**City of North St. Paul
Planning Commission
Regular Meeting Agenda**

- A. ZCU-21-3 Conditional Use Permit and Structural Height Variance to Allow T.A. Schifsky & Sons, Inc. to install three (3) new silos and a scale.

Date: 5/14/2021
To: Planning Commissioners
From: Eric Zweber, AICP, City Planner
CC: Scott Duddeck, City Manager
Re: Conditional Use Permit Amendment and Height Variance Request for Three (3) New Silos and a Scale at T.A. Schifsky & Sons (2310 Highway 36 E)

Engineering Comments:

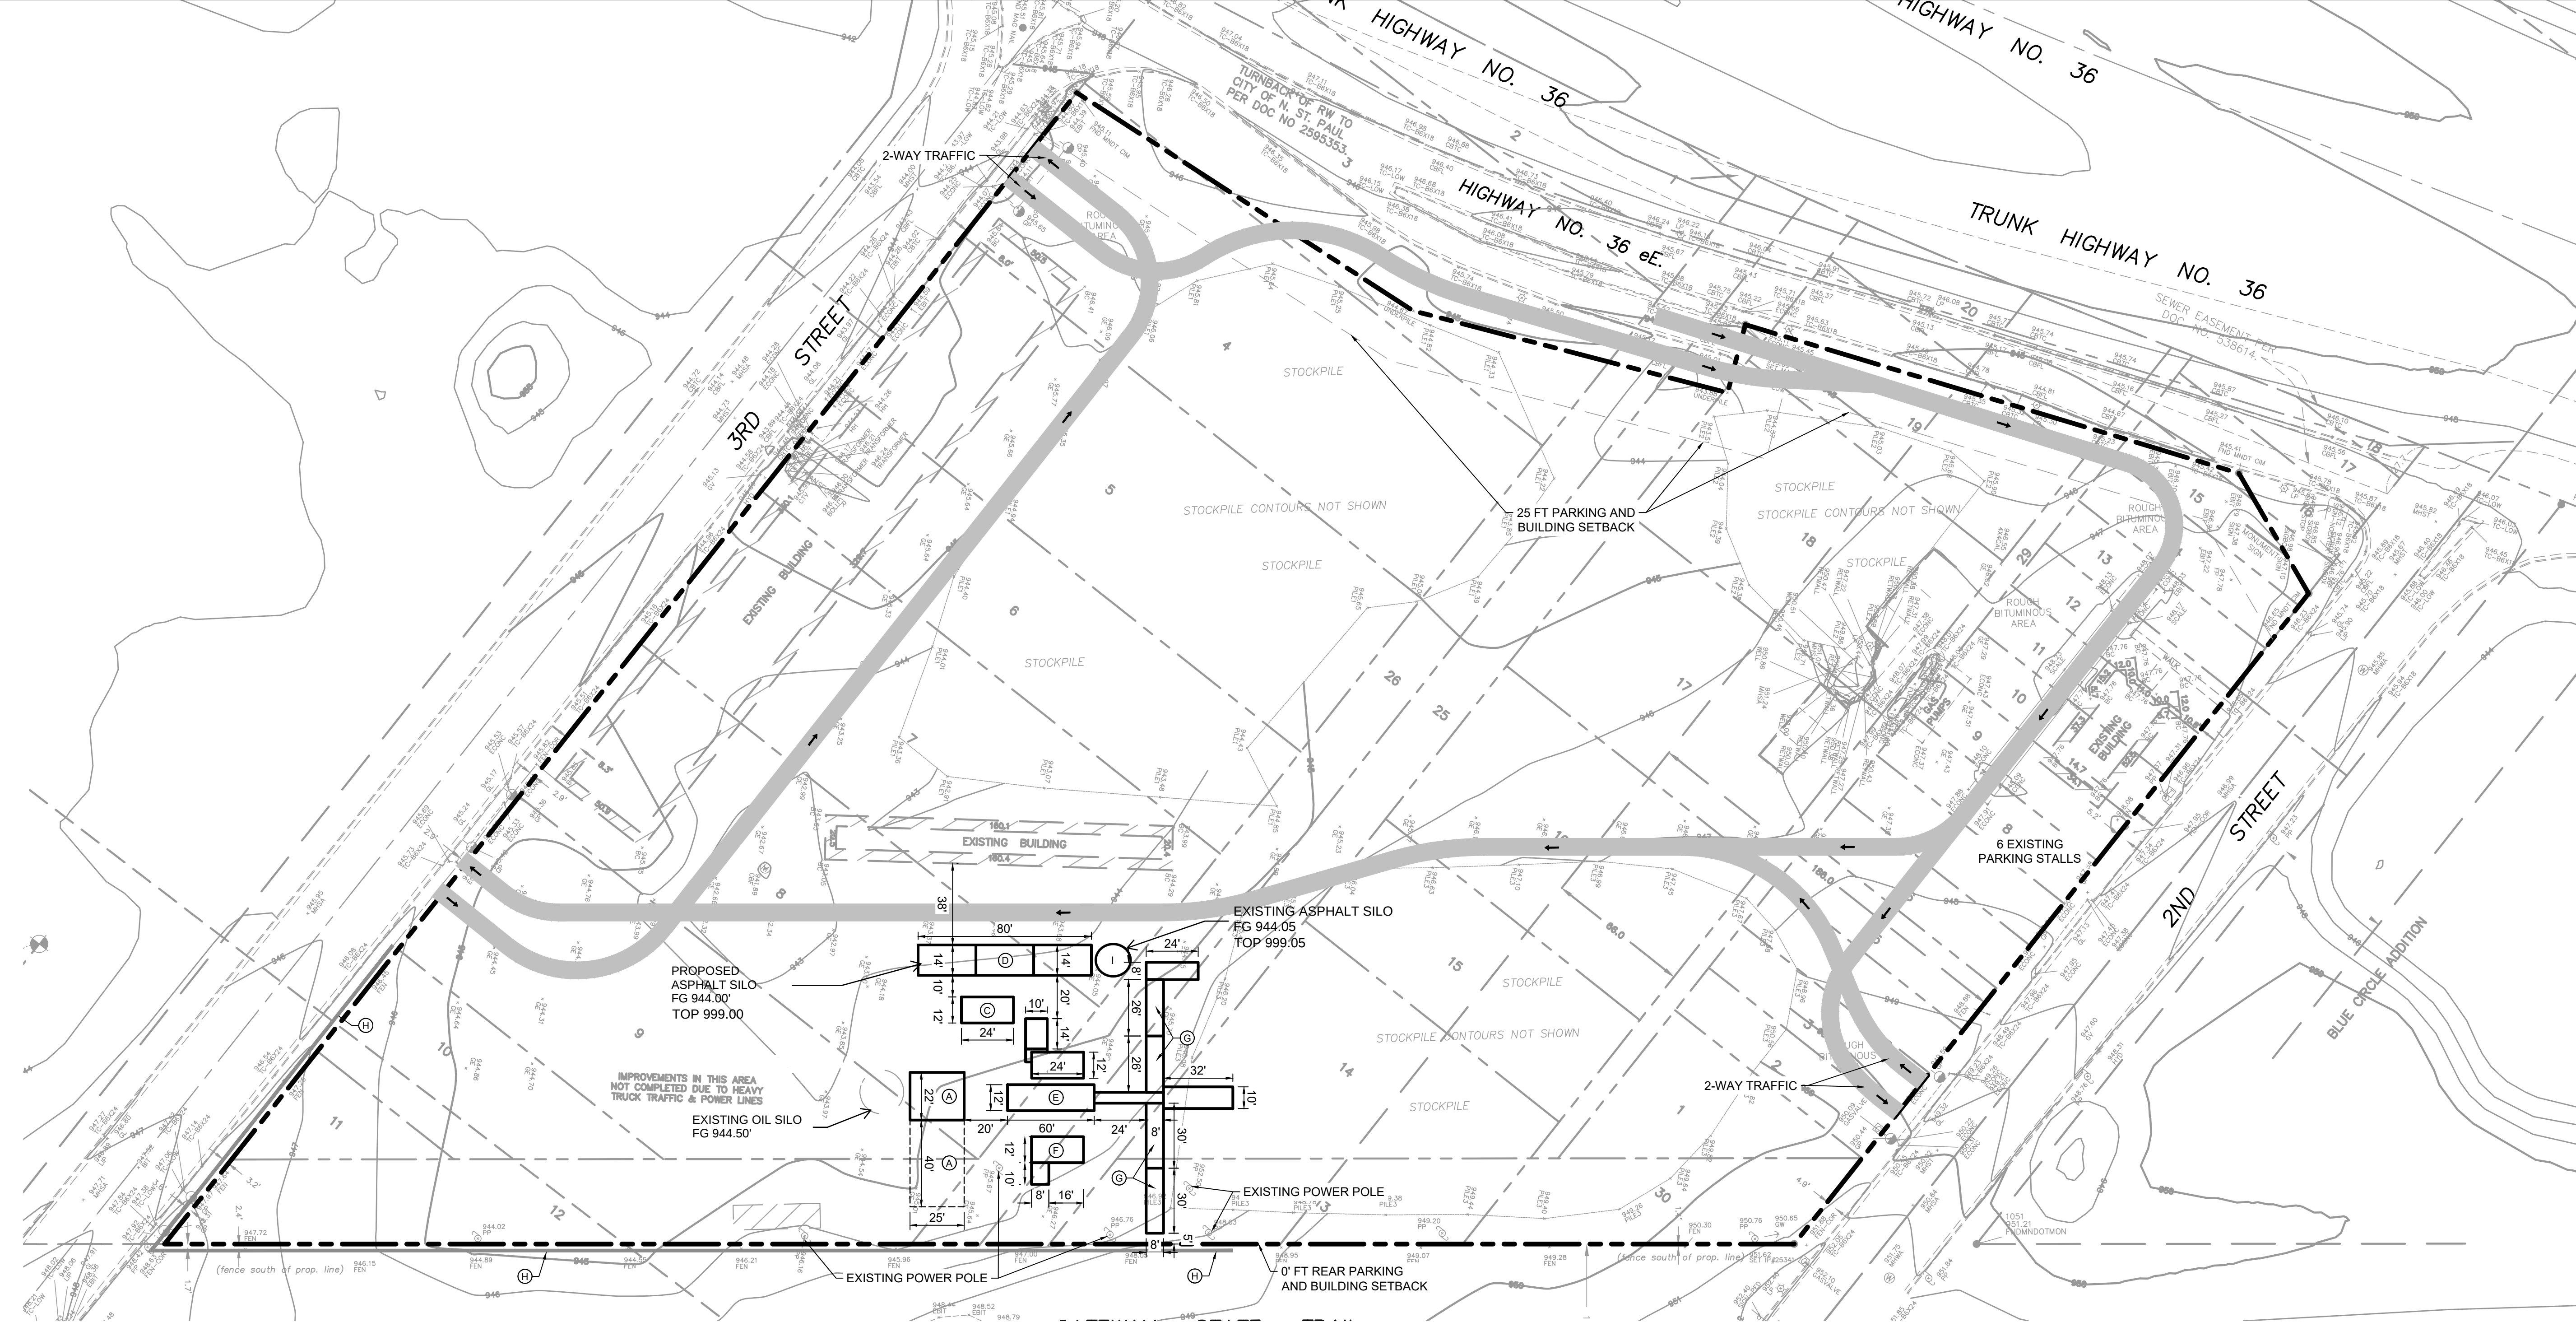
The City Engineer has preliminary reviewed the application. The Engineering concerns are included in the proposed conditions of approval and will be reviewed during the building permit process.

1. Revised set of plans shall be submitted prior to building permit issuance for review addressing comments provided and incorporating any recommended comments as acceptable and necessary.

2. The southern access onto 3rd St N shall be relocated to align with the centerline of the Anchor Dive right-of-way on the west side of 3rd St N.
3. The applicant shall update their site plan to verify paved surfaces at each entrance to minimize sediment tracking on city streets. The failed concrete commercial driveway entrance at the south entrance off 3rd Street shall be replaced with a new commercial apron meeting city standards.

4. The applicant is responsible for and shall provide copies of all applicable permitting for the project prior to grading permit (mass grading) and/or building permit issuance, including but not limited to RWMWD and Minnesota Pollution Control Agency (MPCA) NPDES stormwater construction, City Erosion and Sediment Control Plan, MPCA/Metropolitan Council sanitary sewer extension, and Minnesota Department of Health watermain extension permits, as applicable.
